Technical Service Bulletin: TSB101068

QSK45/60 Power Cylinder Replacer Service Tool Kit Rubber Casing Replacement

Correct Material

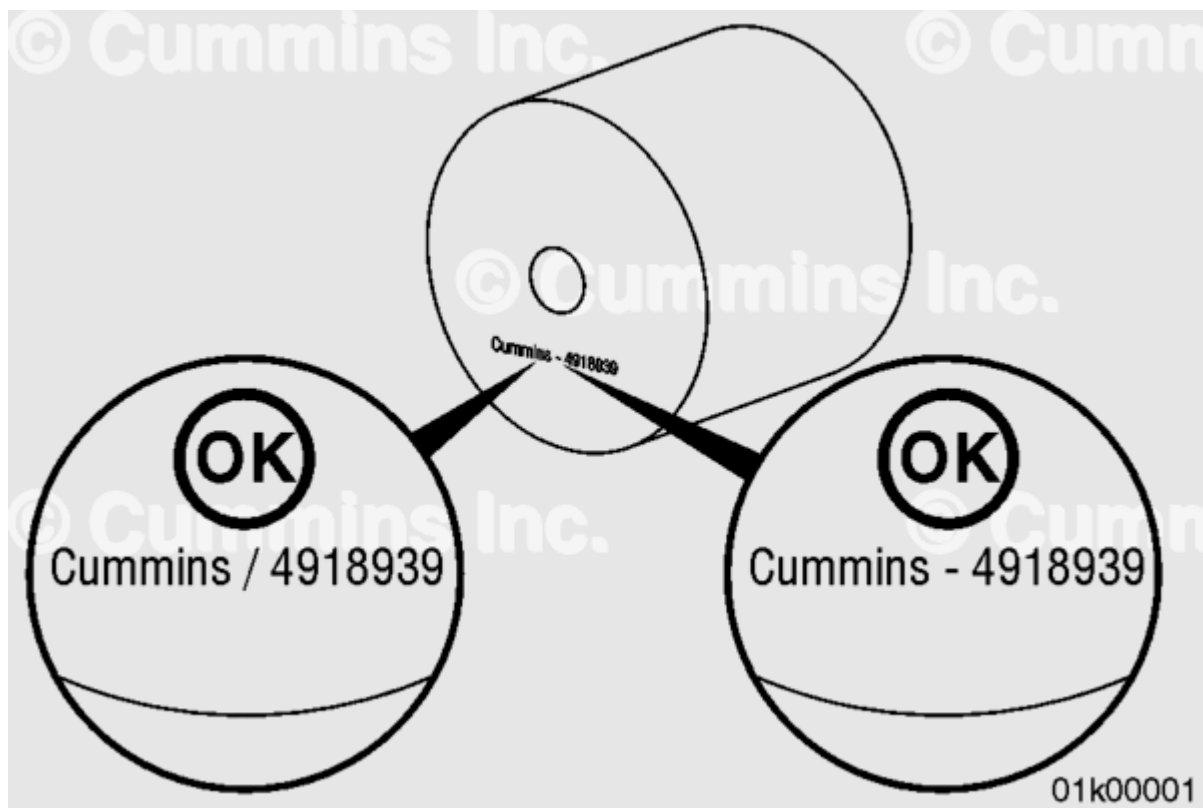
Rubber casings made from the correct material will have a forward slash marking or hyphen between the word Cummins® and the part number. The rubber casings that require replacement will **not** have this mark (see illustrations above). Each rubber casing returned is also eligible for replacement for the replacer plate, Part Number 4918944 (see instructions below).

Incorrect Material

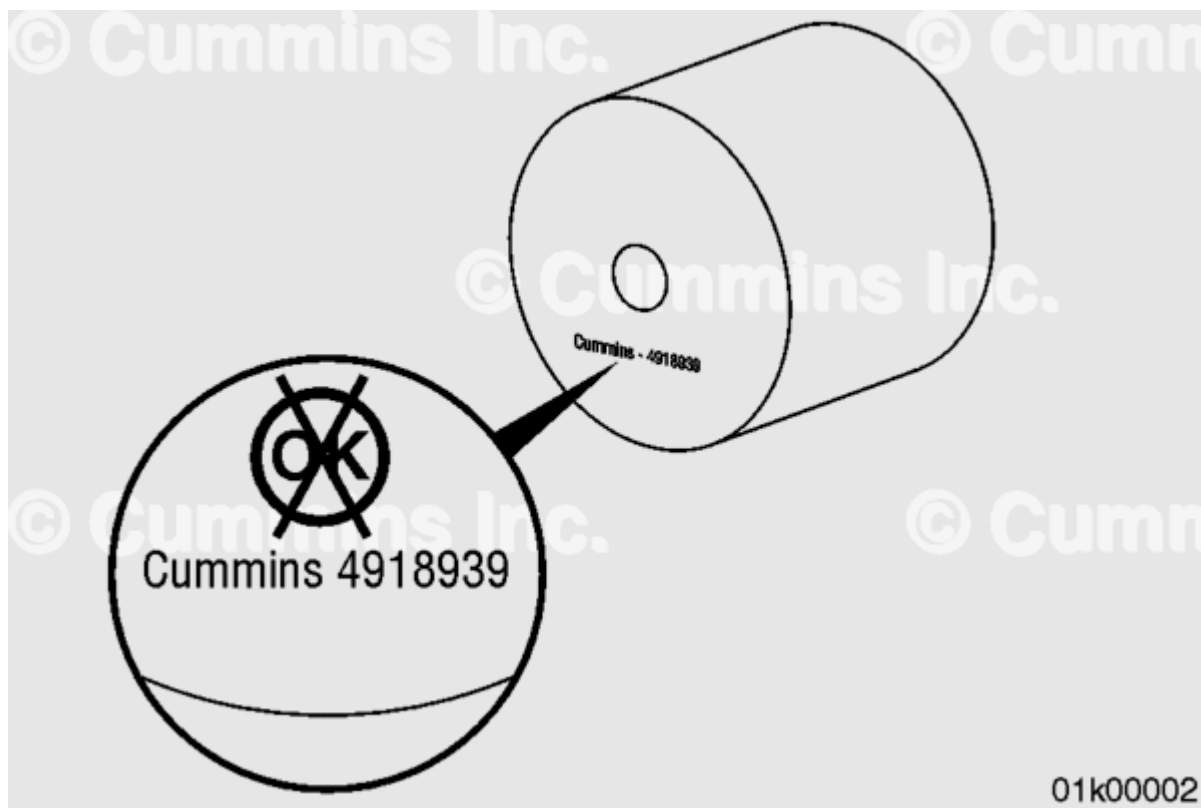
This document addresses the rubber casing, Part Number 4918939, supplied with the power cylinder replacer, Part Number 4919227, (also used in Part Number 4918985 and Part Number 4918950) that was manufactured using the incorrect material. Replacements for the rubber casing, Part Number 4918939, will be provided to customers that purchased power cylinder replacer, Part Number 4919227, cylinder liner replacer, Part Number 4918985, rubber casing, Part Number 4918939, and/or power cylinder replacer, Part Number 4918950. In addition, it has been determined the replacer plate, Part Number 4918944, can permanently deflect under recommended torque loads. A new replacer plate, Part Number 2892303, has obsoleted and superseded the replacer plate, Part Number 4918944, and will be provided to customers that purchased power cylinder replacer, Part Number 4919227, cylinder liner replacer, Part Number 4918985, and/or power cylinder replacer, Part Number 4918950.

If your rubber casing requires replacement, a warranty claim will need to be filed through the Service Products group against the rubber casing, Part Number 4918939, and the replacer plate, Part Number 4918944, **only**. Service Products will review the claim and process it for reimbursement. Once you receive reimbursement, an order may be placed for the new rubber casing, Part Number 4918939, and the replacer plate, Part Number 2892303.
